## Access Compliance Report Public Rights-of-Way (Curb Ramps)

Intersection ID: 27490 Main Street: BALLANTYNE\_COMMONS\_PY Cross Street: JOHNSTON\_RD Location: NE

ADA ID: DC3797F50DB0 Ramp Type: Perp Initial Pass/Fail: Fail Overall Compliance: No Severity Score: 12.5

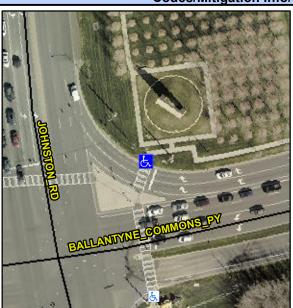
Possible Solution	
Possible Solutions:	9
Remove & Replace Entire Ramp.	
	١
	N
	N
	N
	1
Surveyor Notes:	1
N/A	1
	1
	1
	1
PROW/ADA:	1
R304.2.2	N
	N
	N

Comp	liance Description	Data	Comp	liance Description	Data
N/A	Ramp Length (in)	72.0	No	Ramp Slope (%)	9.4
Yes	Ramp Width (in)	59.0	Yes	Ramp XSlope (%)	1.8
N/A	Flare Type LT	N/A	N/A	Flare Type RT	N/A
N/A	Flare Slope LT (%)	N/A	N/A	Flare Slope RT (%)	N/A
N/A	Flare Traversable LT?	N/A	N/A	Flare Traversable RT?	N/A
N/A	Landing Length (in)	N/A	N/A	DWS Provided?	N/A
N/A	Landing Width (in)	N/A	N/A	DWS Contrast?	N/A
N/A	Landing Slope (%)	N/A	N/A	DWS Length (in)	N/A
N/A	Landing X Slope (%)	N/A	N/A	DWS Full Width?	N/A
N/A	Landing Curb? (Y/N)	N/A	N/A	DWS Offset (in)	N/A
N/A	Shared Landing?	N/A			
N/A	Gutter Ponding?	N/A	N/A	Gutter Slope (%)	N/A
N/A	Gutter Lip Ht (in)	N/A	N/A	Gutter X Slope (%)	N/A
N/A	Painted X Walk1?	Yes	N/A	Painted X Walk2?	N/A
	X Walk 1 Direction	To SW		X Walk 2 Direction	N/A
N/A	X Walk 1 Width (in)	120.0	N/A	X Walk 2 Width (in)	N/A
	X Walk 1 Slope (%)	1.7		X Walk 2 Slope (%)	N/A
	X Walk 1 X Slope (%)	1.8		X Walk 2 X Slope (%)	N/A
